**ADDENDUM 1**

NEW TERMINAL BUILDING CRAWFORD COUNTY AIRPORT AUTHORITY

WHITE & BORGOGNONI ARCHITECTS, P.C. ADDENDUM #1

AD1.1

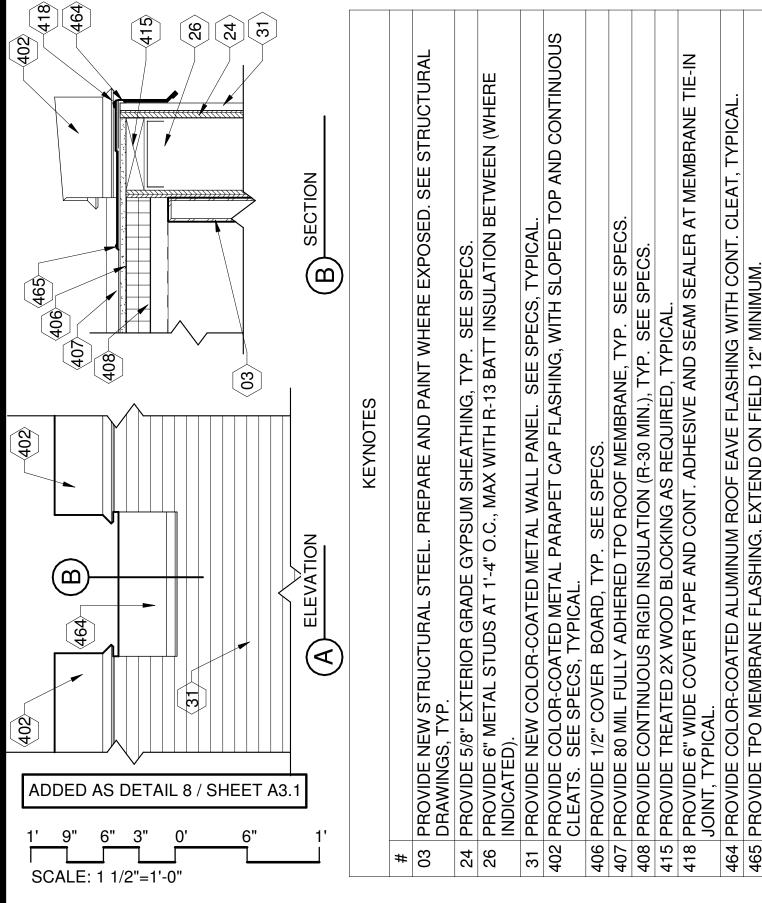
KEYNOTES	
#	
404	PROVIDE NEW VENT PIPE. SEE VENTILATION AND PLUMBING DRAWINGS FOR SIZE AND LOCATIONS, TYPICAL.
405	PROVIDE NEW PRE-FORMED BOOT FLASHING WITH STAINLESS STEEL CLAMPING RING. SEE SPEC., TYP.
406	PROVIDE 1/2" COVER BOARD, TYP. SEE SPECS.
407	PROVIDE 80 MIL FULLY ADHERED TPO ROOF MEMBRANE, TYP. SEE SPECS.
408	PROVIDE CONTINUOUS RIGID INSULATION (R-30 MIN.), TYP. SEE SPECS.
409	PROVIDE METAL ROOF DECK, TYP. SEE STRUCTURAL DRAWINGS.
494	PROVIDE FASTENERS AND FASTENER PLATE PER MANUFACTURER'S REQUIREMENTS TO MEET SPECIFIED WARRANTY. FASTENERS TO BE ADEQUATELY ANCHORED TO ROOF DECK.

METAL WALL PANEL SILL FLASHING DETAIL AT ROOF

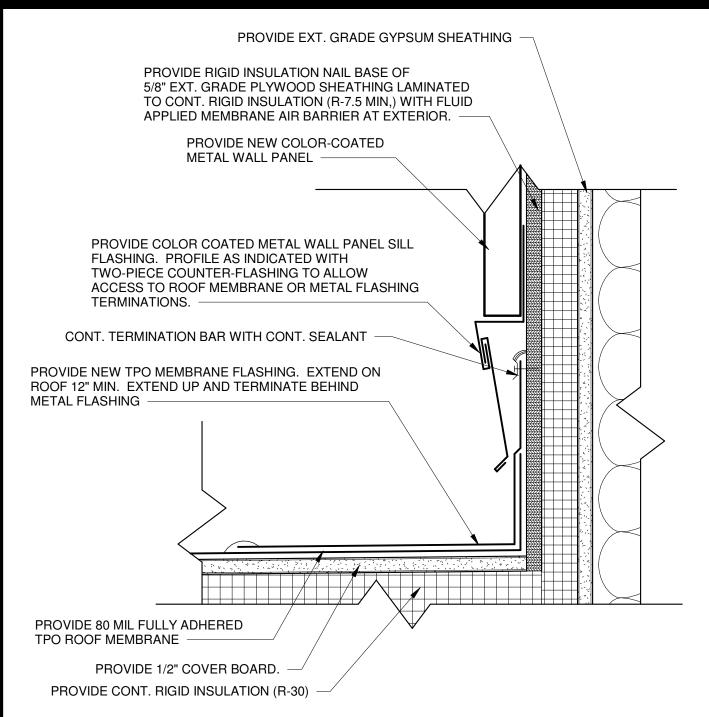
ADDED AS DETAIL 10 / SHEET A3.0

NOTE: FLASHING CONDITION APPLICABLE TO AREAS WITH ROOF TRANSITION BELOW METAL WALL PANEL. PROVIDE TWO-PIECE COUNTER-FLASHING TO ALLOW ACCESS TO ROOF MEMBRANE OR METAL FLASHING TERMINATIONS. AT AREAS WITHOUT ROOF TRANSITIONS BELOW, PROVIDE TYPICAL METAL PANEL SILL FLASHING.

**CASEWORK - DRAWER UNIT**

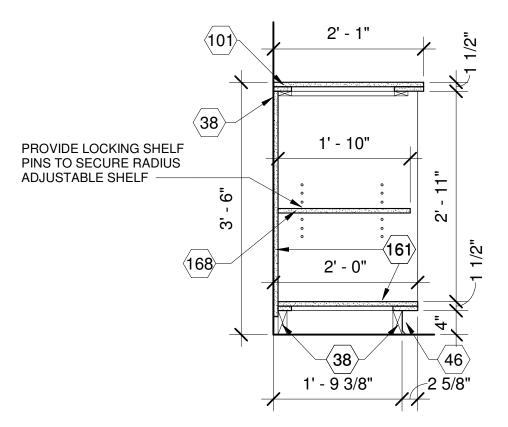
ADDED AS DETAIL 22 / SHEET A7.1
